Report on the Activities of the TF on ADAS

Draft Amendments to UN Regulation No. [171]

– Outline & Justification –

4. To confirm the specific requirements for lane change with an approaching vehicle

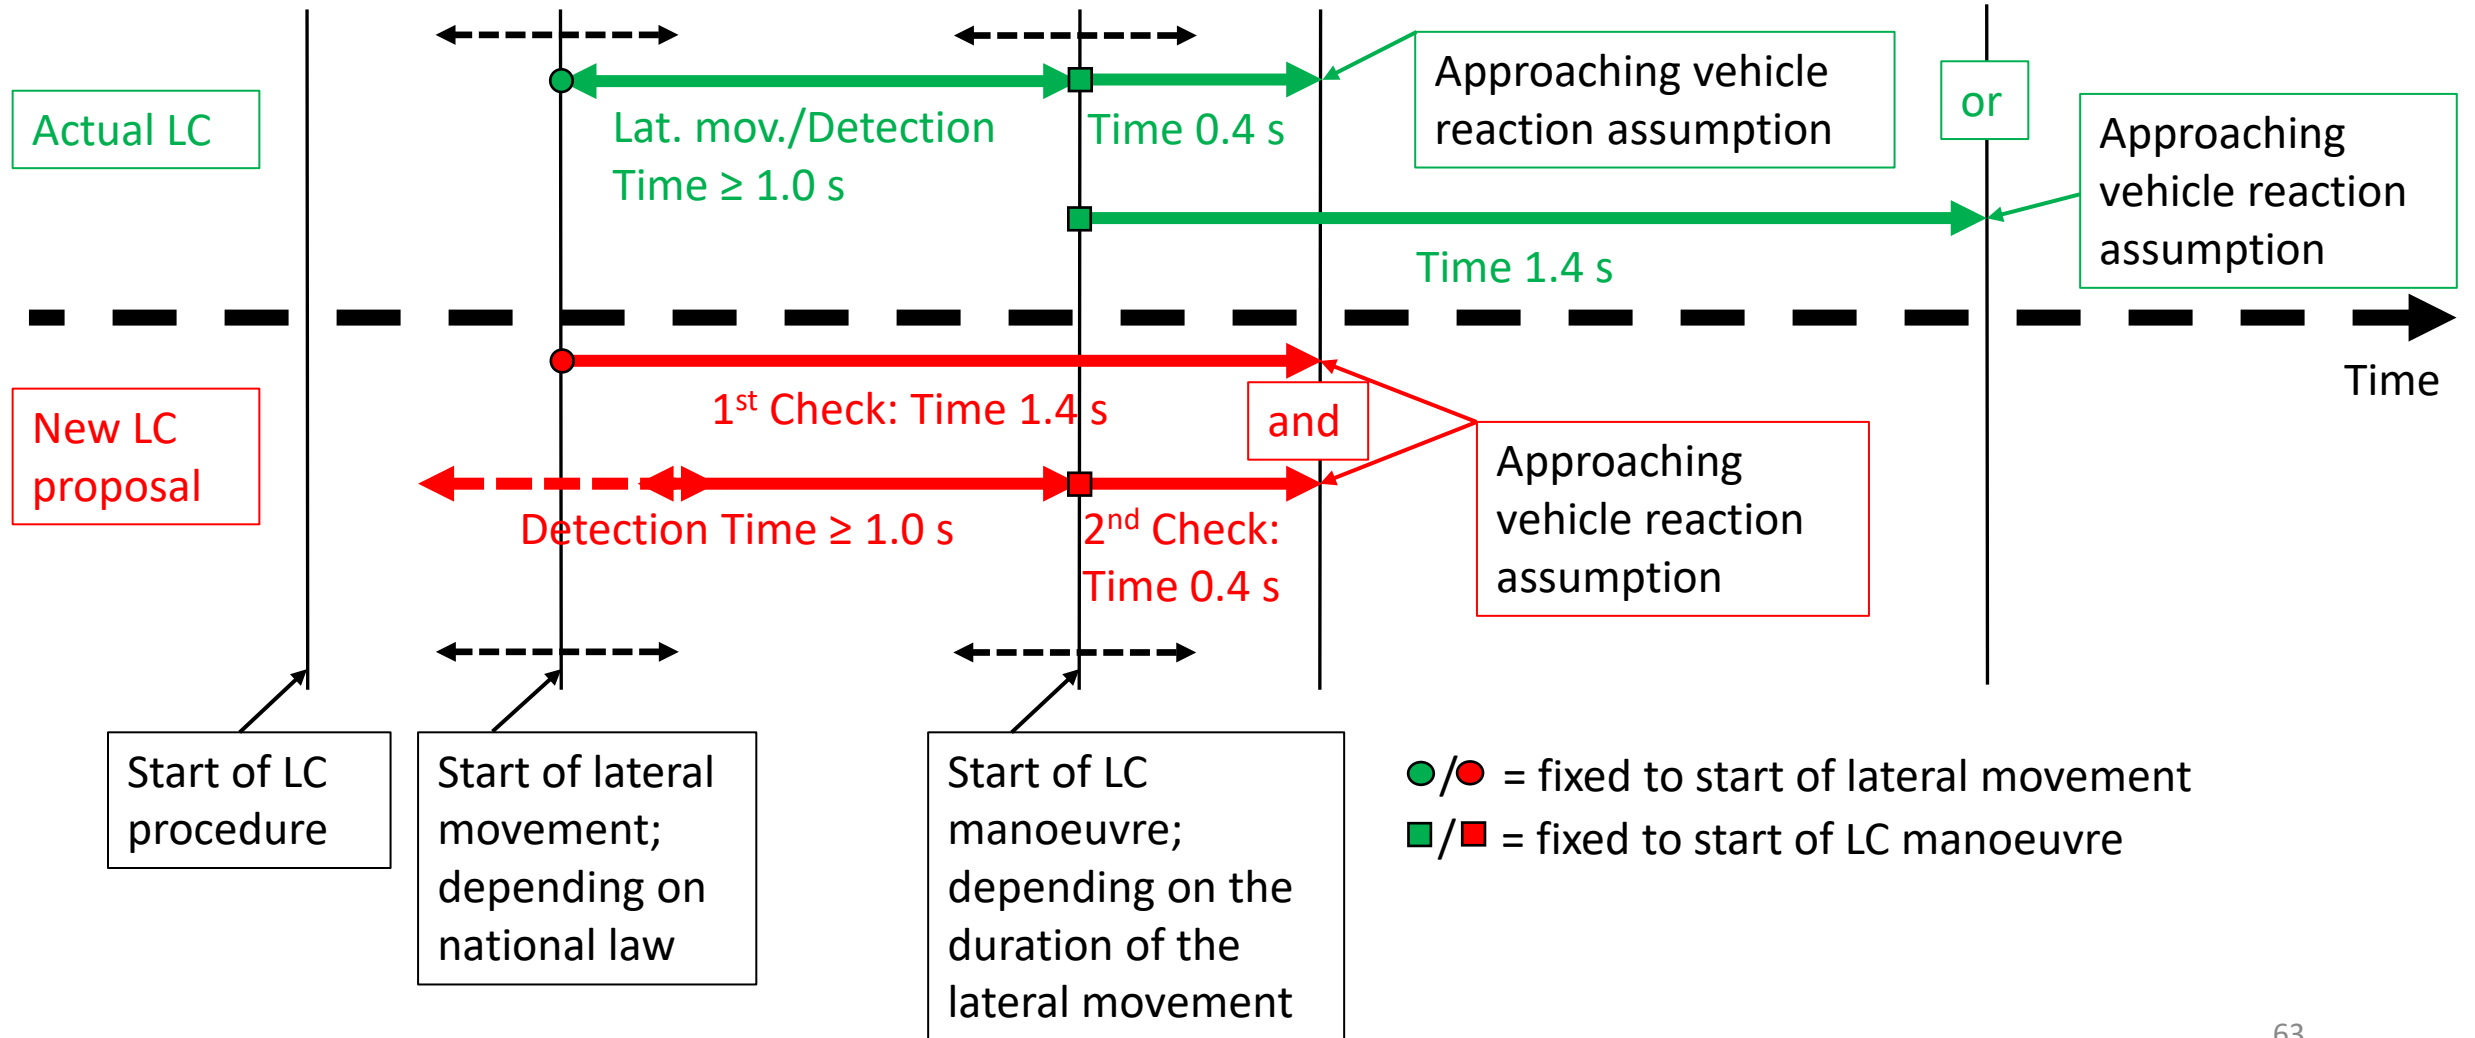
[The system shall be designed to not make an approaching vehicle decelerate at a higher level than 3.0 m/s^2 ,

(a) 1.4 seconds after the system starts the lateral movement of the lane change procedure; and

(b) 0.4 seconds after the system starts the lane change manoeuvre, provided that the approaching vehicle was detected by the DCAS vehicle for a duration of at least 1.0 seconds immediately before the lane change manoeuvre starts, if applicable,

to ensure that the distance between the two vehicles is never less than that which the DCAS vehicle travels in 1 second.]
